November 2, 2012
NRC:12:056

Response to an RAI on Topical Report ANP-10301(P), Revision 0, "Statistical Universal Power Reconstruction with Fixed Margin Technical Specifications"

Figure 1 — The Statistical Universal Power Reconstruction Portion of the SUPR-FMTS System

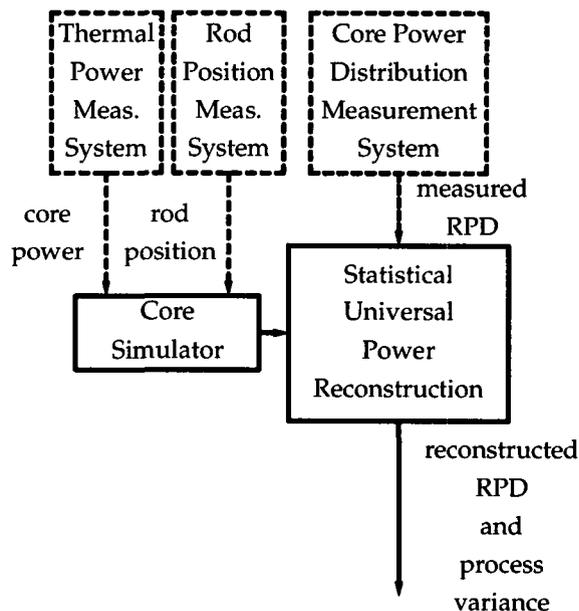
1 What further work is required for implementation in a particular plant?

One or more currently approved core relative power distribution (RPD) measurement systems will be used to provide periodic power distribution measurements to the SUPR-FMTS system [1]. These must be systems with prior approval, including a quantified measurement uncertainty. Examples of currently existing systems include Movable Incore Detector (MIDs) and Fixed Incore Detectors (FICs). The methods and software to process the detector signals to produce the measured RPDs in instrumented locations are previously approved. The SUPR-FMTS system also uses other measured plant parameters such as thermal power level and control rod position, as shown in Figure 1.
